A few thoughts on Clause  
P802.3bz D1.0, 126.5.4.3  
(2.5G/5GBASE-T Receiver  
Common-Mode Noise Rejection)

Pete Cibula  
Intel Corporation

# Rx CMNR Source Voltages

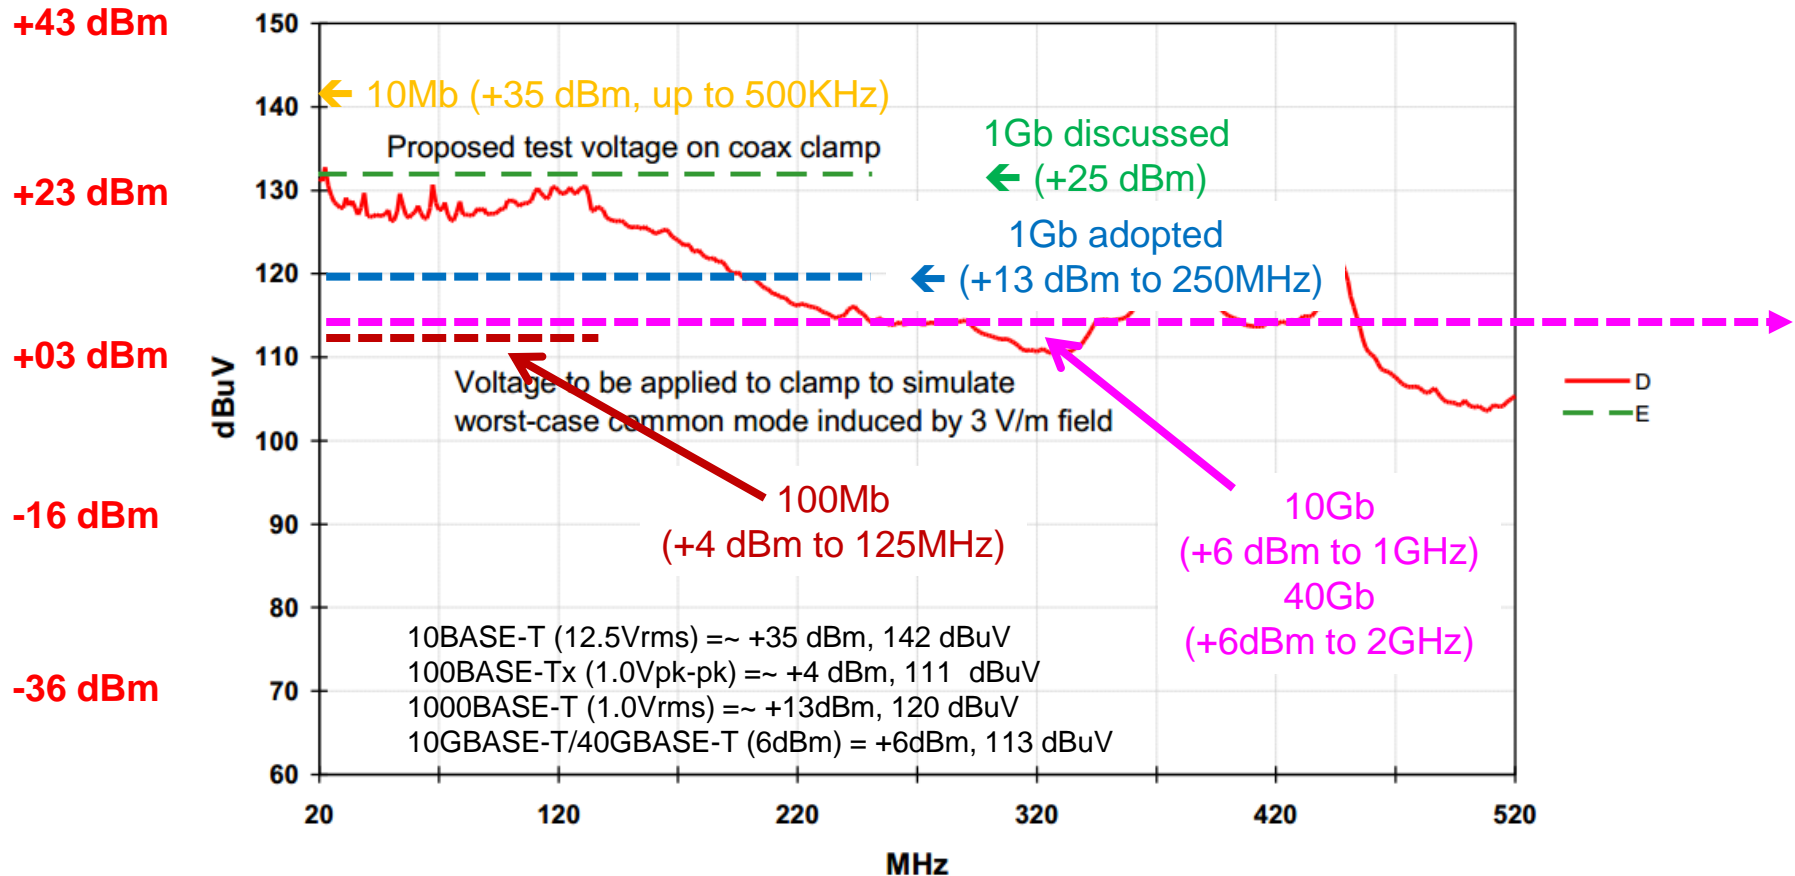
- Should we add a CMNR test to the standard? **YES!**
- What frequency range should we use?
  - **Propose 80MHz to 1GHz**
    - Low frequency aligns with other MultiGBASE-T PHYs (Clause 55, Clause 113)
    - High frequency aligns with IEC 61000-4-3, 5.1 Test levels related to general purposes
- What set of frequency points and dwell time should we use?
  - Suggest using IEC 61000-4-3 for guidance.
    - **Propose minimum 500ms/step**
    - **Propose minimum 255 points for “1% maximum” step size**, but do not prohibit other frequency step spacing or number of points
  - Update to Annex 113A?
- Proposed required levels for signal generator output level
  - Suggest targeting “3V/m equivalent” source levels to align with other twisted pair standards, especially the 1000BASE-T/Cat5e system
  - **Propose injected source power level of +13dBm**

Proposed clamp voltage for tests

# “NOTE 1” Test Configuration

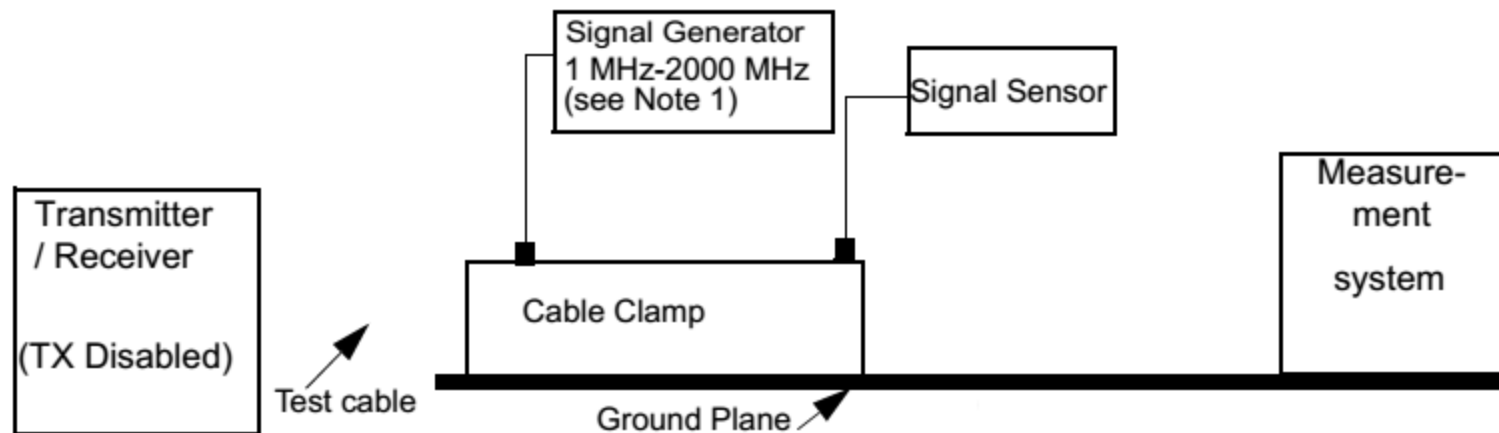
NOTE 1 —Prior to making validation measurements or performing the test described in 113A.4, the cable clamp should be tested without the cable inserted to determine the variation of the signal generator voltage with frequency at the output of the clamp. The signal generator output should be adjusted to the specified signal power (for example 6 dBm for 40GBASE-T) at 20 MHz on the signal sensor. When the frequency is varied from 1 MHz to 2000 MHz, the measured power should not vary more than  $\pm 10\%$ . If the measured power varies more than  $\pm 10\%$ , then a correction factor must be applied at each measurement frequency.

Coaxial clamp response to constant 6dBm input

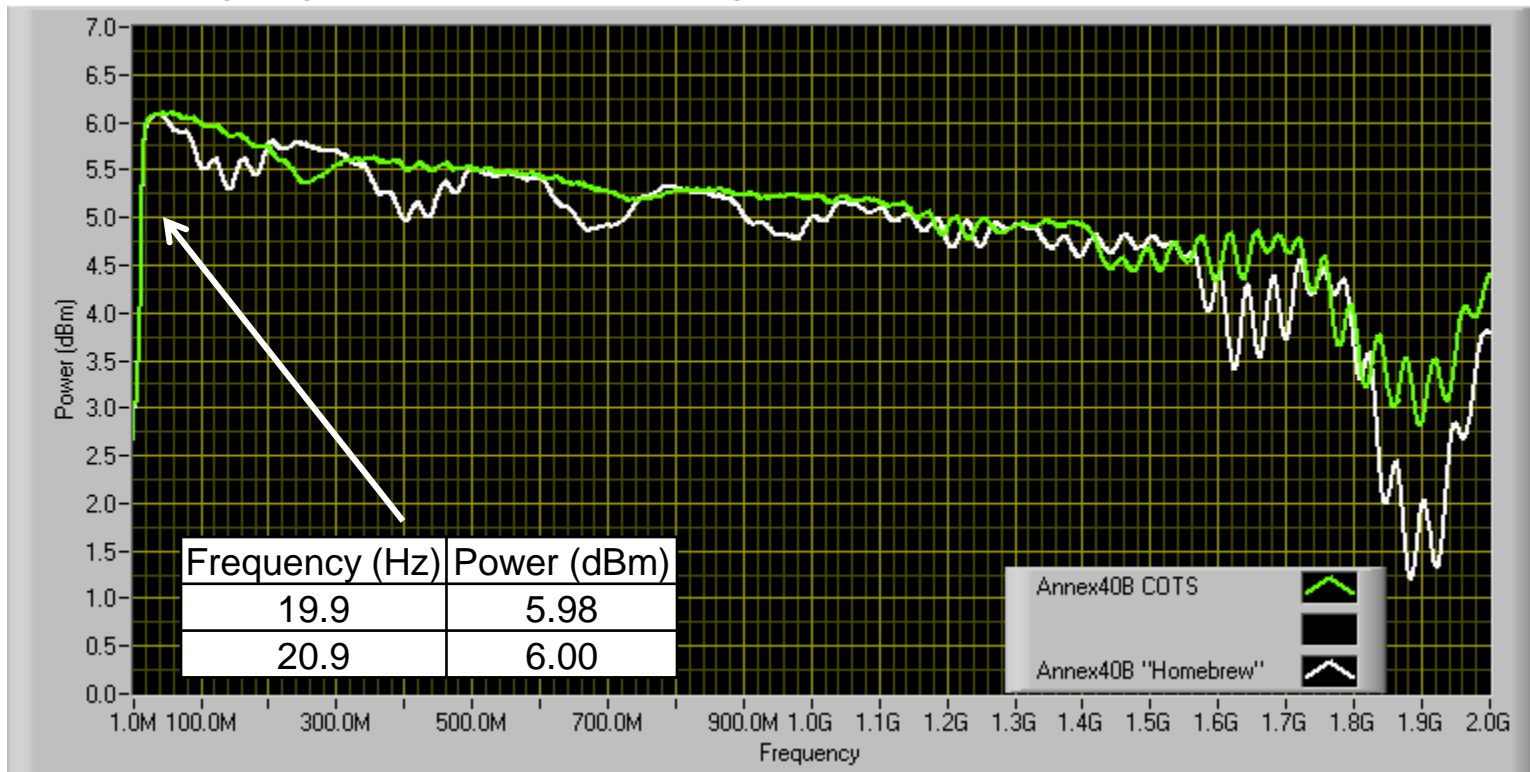
Constant 6dBm input to two “empty” coaxial clamps  
1MHz – 2000MHz, 2005 steps, 1MHz spacing  
Losses can be easily corrected
